Hearing #1

Hearing #2

Hearing #3

**NW OVERTON STREET**

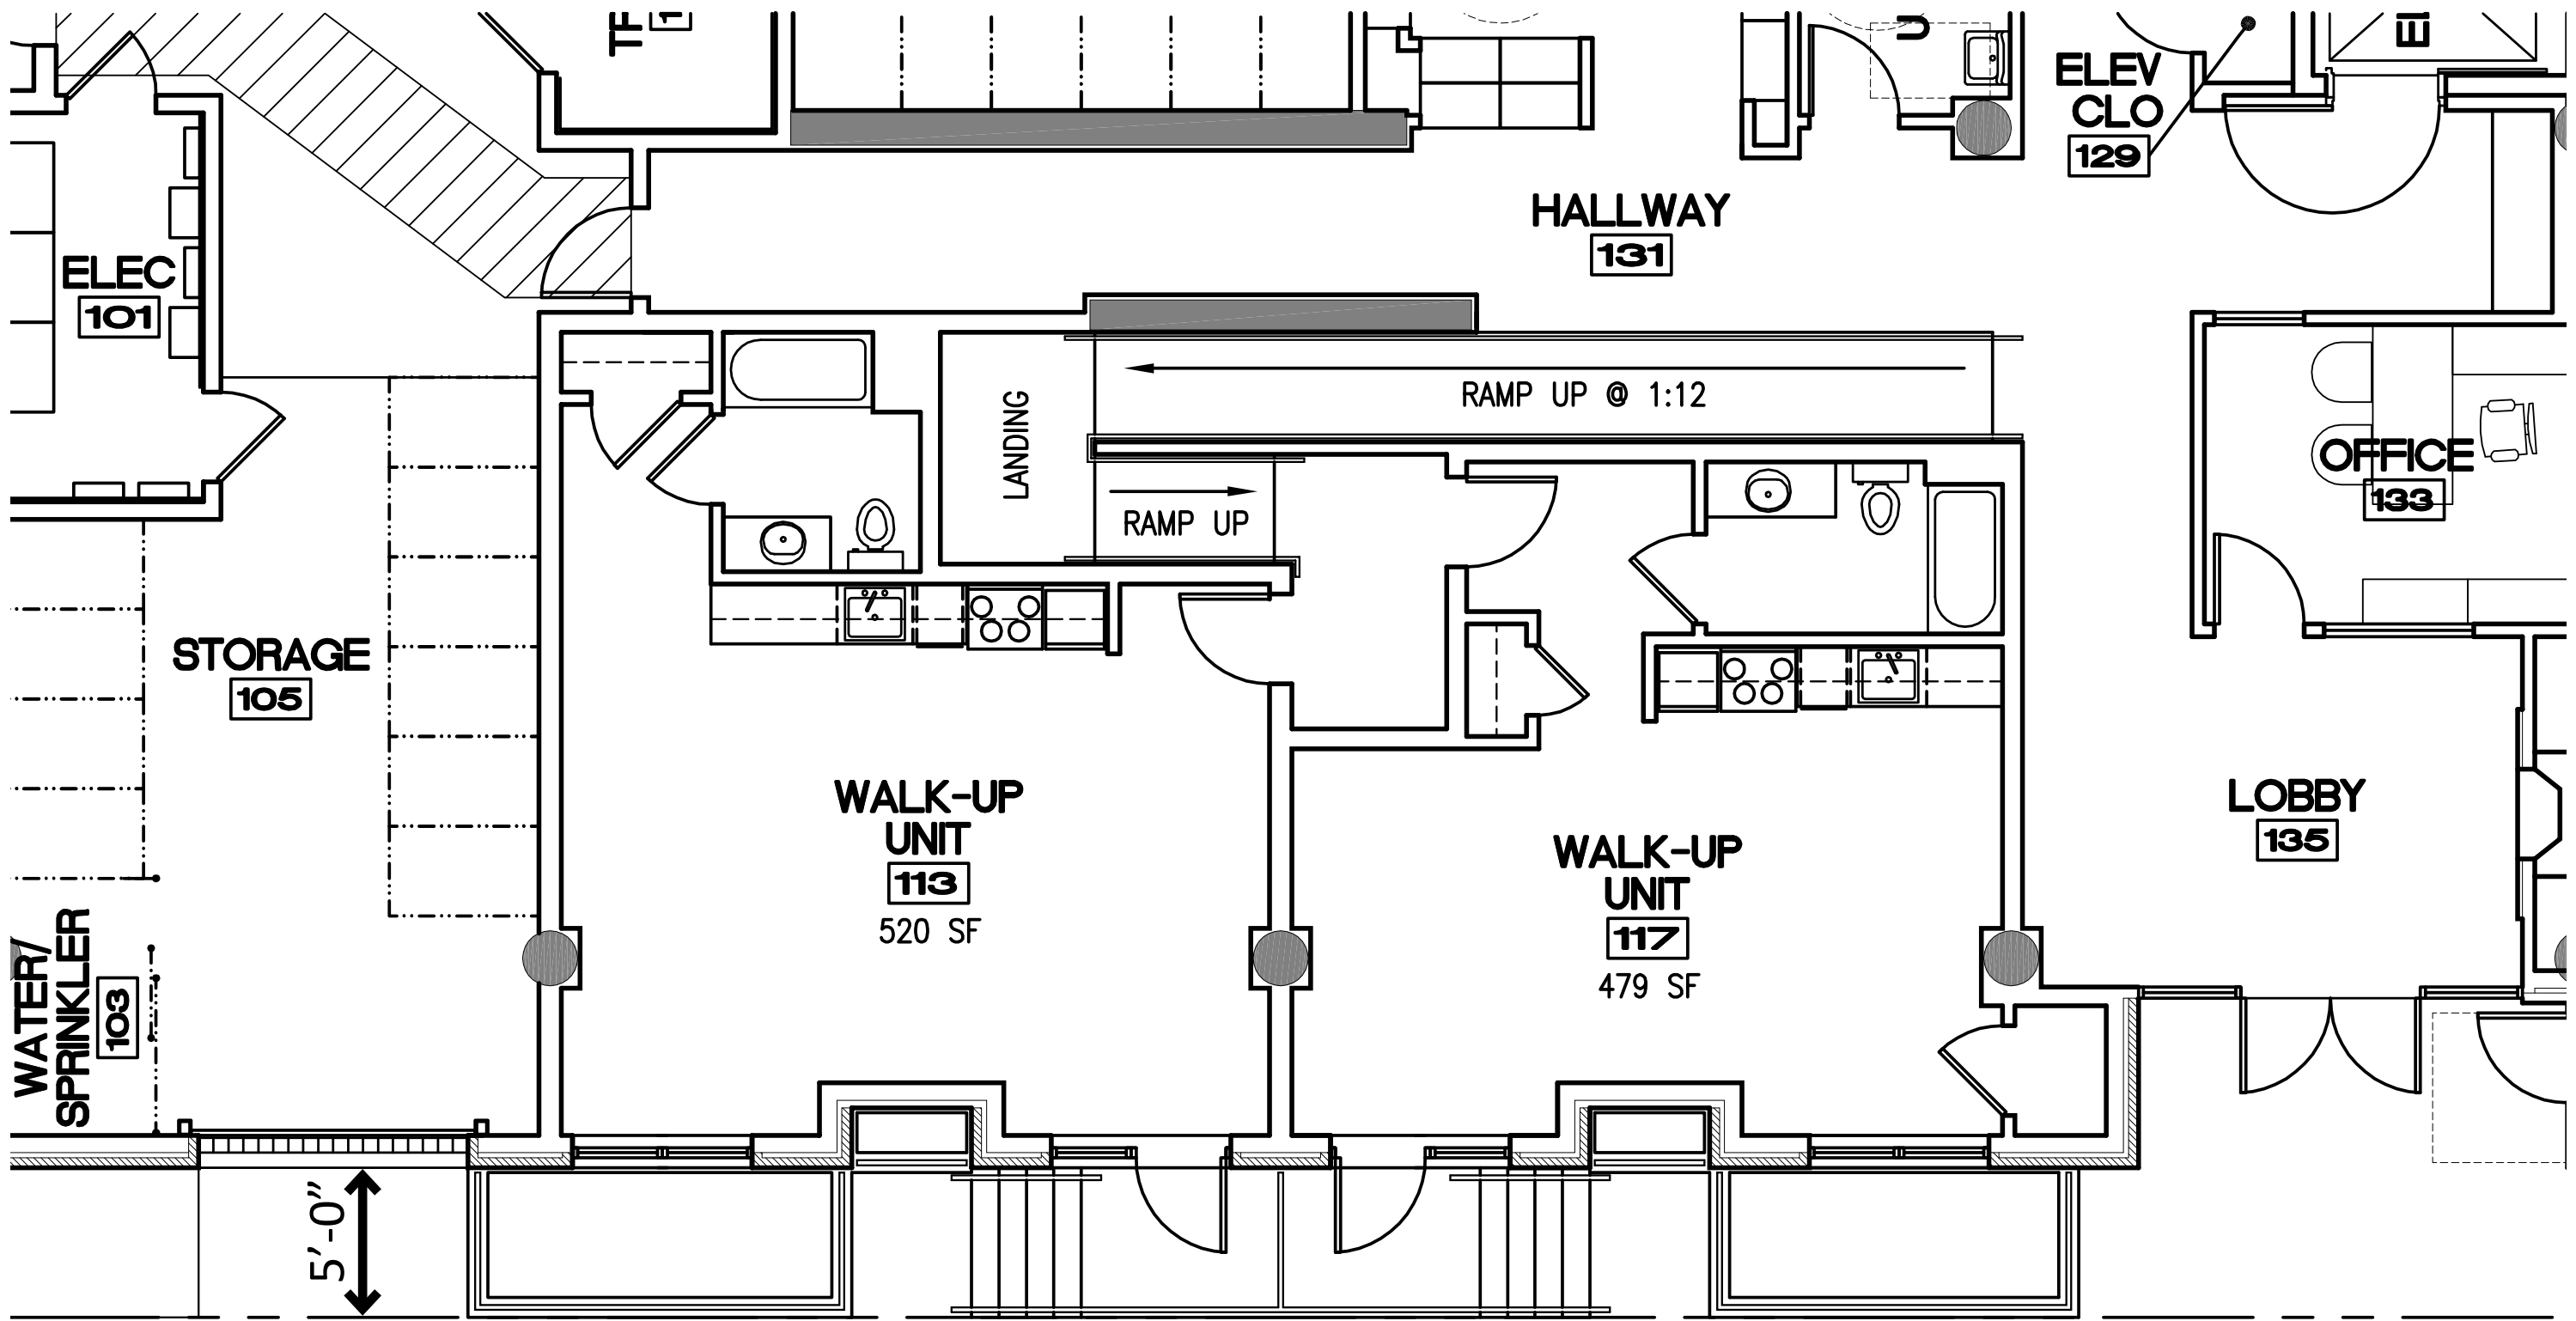
- Additional study of context to identify the different street characters
- Brick added to the entire façade of the Overton building
- Overton elevation redesigned to improve the composition and harmony

- Fiber cement siding eliminated in favor of traditional stucco
- Residential units at Pettygrove ground story converted to a Live/Work space
- Overton Building relocated 3 feet to provide 5 foot setback

- Four residential units at Overton ground story converted to larger apartments with exterior entry stoops
- Ground floor opening heights raised to 11 feet for both buildings

- Ground floor canopy heights raised for both buildings
- Area added at main entry alcoves to conceal emergency exit doors for both buildings
- Overhead glass doors to interior bike parking added at courtyard facing elevations

- Shelters provided at all exterior bike parking
- Overton Building revised to provide 3 feet high stoop entries for the residential units
- Courtyard facade detail provided for recessed spandrel panels

- Design studies provided of end walls and courtyard walls to connect more directly to historic precedent
- Design studies of courtyard canopies in polycarbonate & wood or steel
